Subject: Port Hope Project – CNSC Comments on AECL Work Plan to Increase Collection Pond Capacity at the Welcome Waste Management Facility

Integrated Review of AECL Work Plan for Modification of Collection Ponds at Welcome WMF

Figure 1: Result of berm stability analysis at a flooding condition (using SLOPE/W 2007).

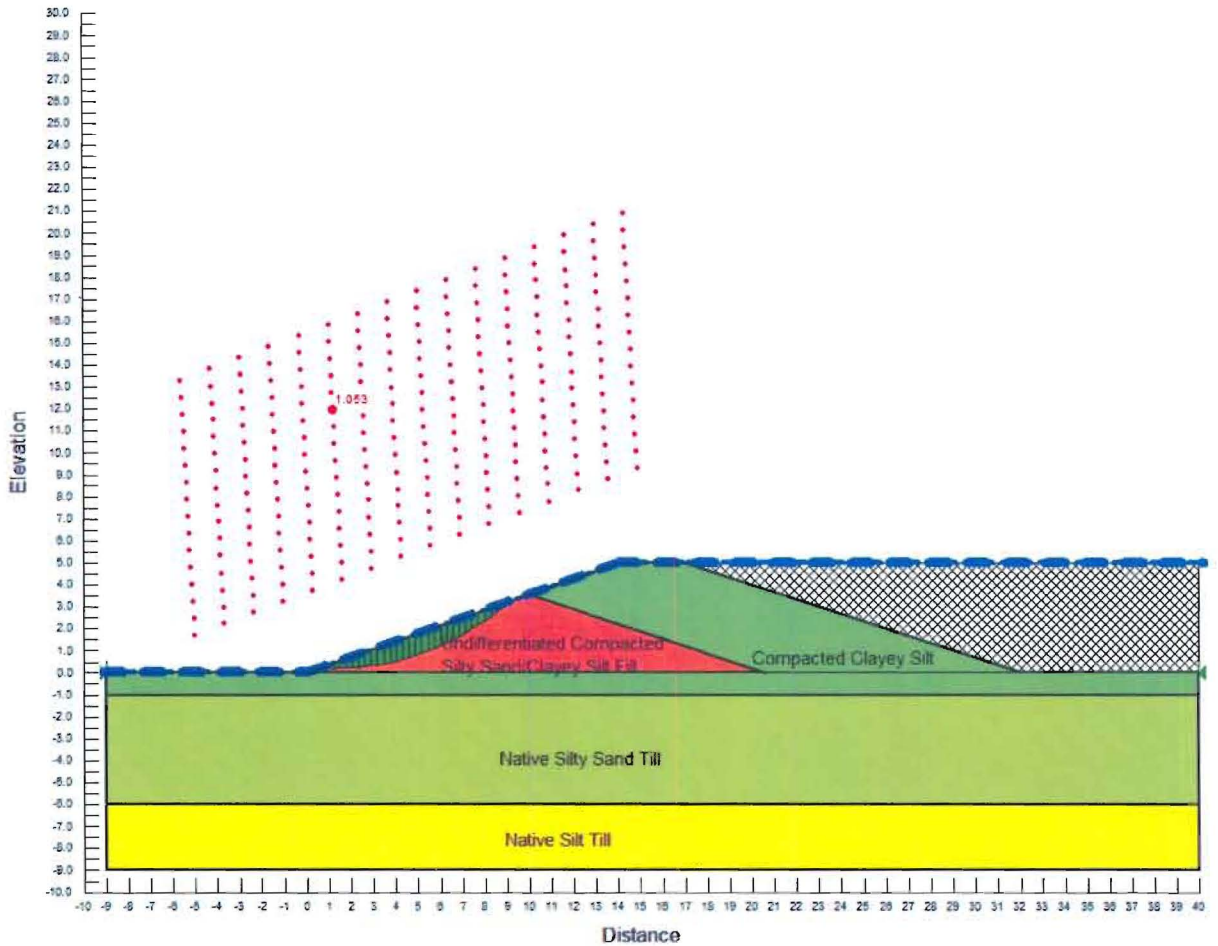
It is Staff's opinion that the berms will not be stable under the proposed design when flooded (*as shown in the attached figure*). Staff proposes the following four recommendations associated with berm stability and pond management. Acceptance of these recommendations by AECL will demonstrate to the CNSC adequate provision of safety and environmental protection.

- *Recommendation 1:* The licensee shall ensure, via pond management measures that perimeter berms at the WWMF are not to be overflowed at any time during the operation of the collection ponds.
- *Recommendation 2:* The downstream gradient of the berms should be evaluated to ensure a less than 1V:3H gradient is maintained to ensure protection of the berm from erosion and compensate for the potential input parameter uncertainty. Berm erosion protection O&M measures should also be conducted.
- *Recommendation 3:* The berm modification construction should be supervised by a Professional Engineer, including assurance from the PE of an adequate compaction of the berm modification.
- *Recommendation 4:* Upon completion of the project AECL should submit to CNSC an as-built technical report of this project.
